**Rea Road Townhomes**  
 Charlotte, NC

FOR PUBLIC HEARING PETITION #2005-161

SHEET TITLE: Site Plan

DATE: August 9, 2006  
 TO: Gary Huss, Zoning Coordinator  
 FROM: Debra Campbell, Planning Director  
 SUBJECT: Administrative Approval for Petition No. 2005-161 Terry Birch.

L1.0

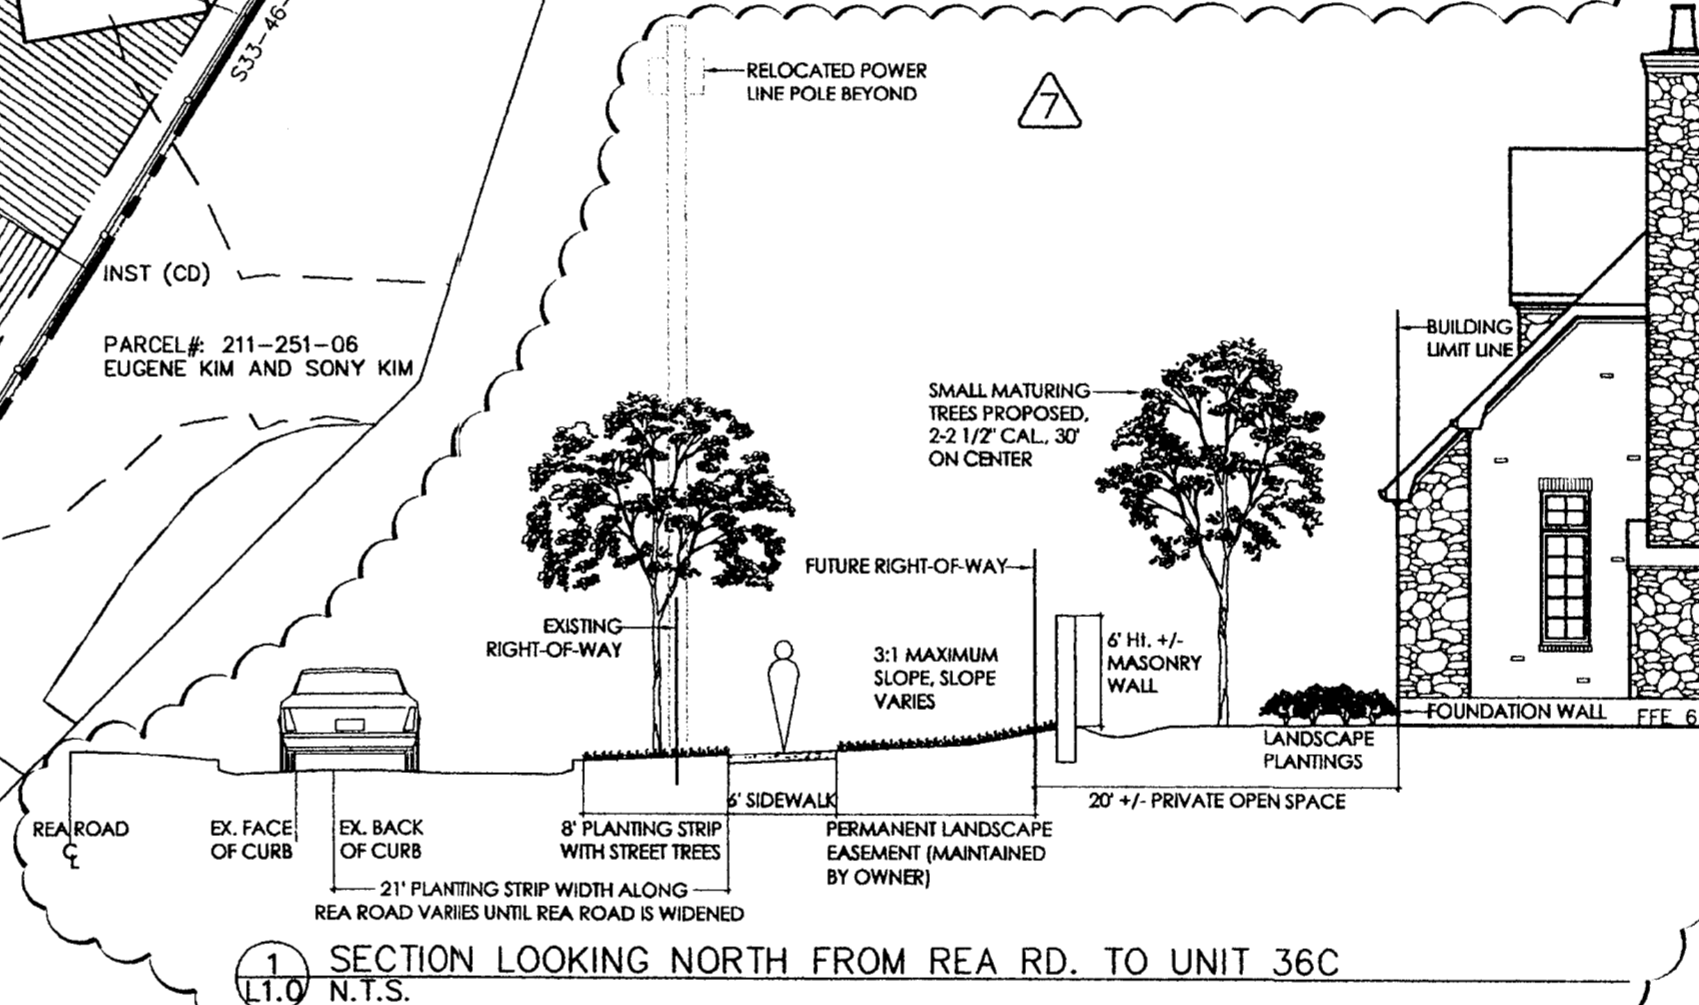
Attached is a revised plan for the above petition. The plan has been revised to allow clearing in the 20-foot building line along Rea Road. The developer will mitigate the trees in this area with additional plantings. Since this change is minor, I am administratively approving this revised plan. Please use this plan when evaluating requests for building permits and certificates of occupancy.  
 All other ordinance requirements still apply.
